Subject: Kilarc-Cow Creek Project (FERC Project No. 606)

Response to FERC Additional Information Request in Letter dated September 3, 2009

Response to AIR

SHASTA COUNTY, CALIFORNIA
 1964*

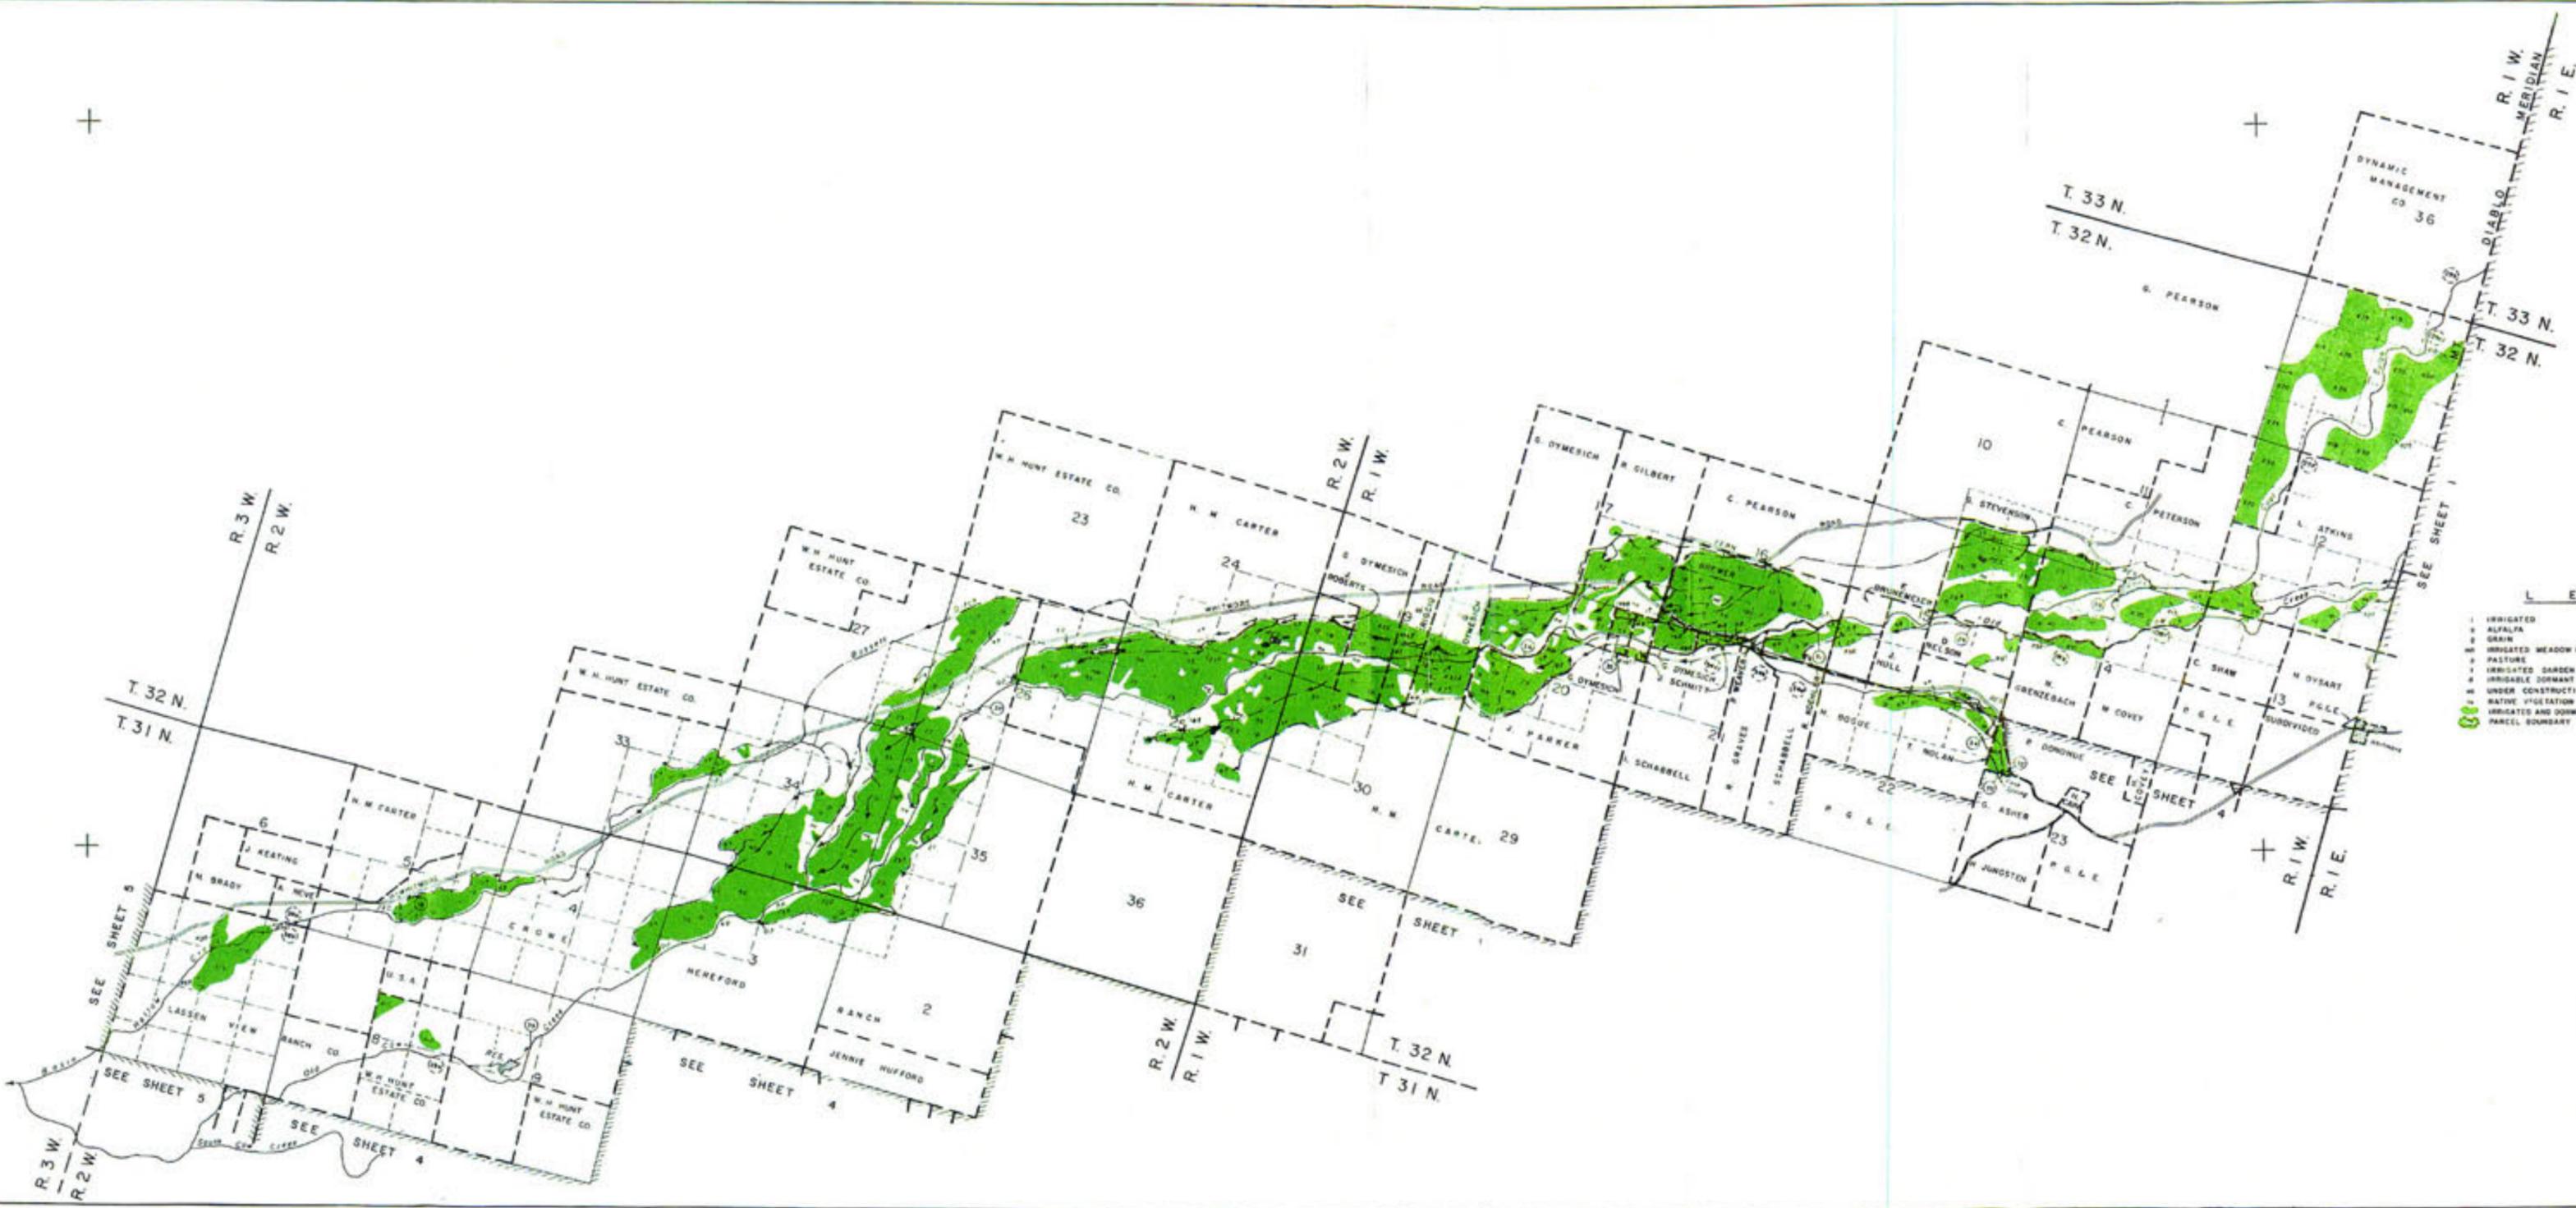
Water Resources Item 3: *Please provide a map of the Old Cow Creek and South Cow Creek basins indicating the location of other diversions and licensed or exempt hydro projects above and below the Cow Creek and Kilarc developments.*

RESPONSE – Water Resources Item 3: Attachment M contains the diversion maps from the 1969 Adjudication of Old Cow Creek, South Cow Creek, and Lower Cow Creek. See "In the Matter of the Determination of the Rights of the Various Claimants to the Water of Cow Creek Stream System Excepting Clover Creek, Oak Run Creek and North Cow Creek in Shasta County, California", Case No. 38577 (Shasta Cty. Sup. Ct., August 25, 1969). The Adjudication remains the operative document codifying water rights for the Cow Creek system.
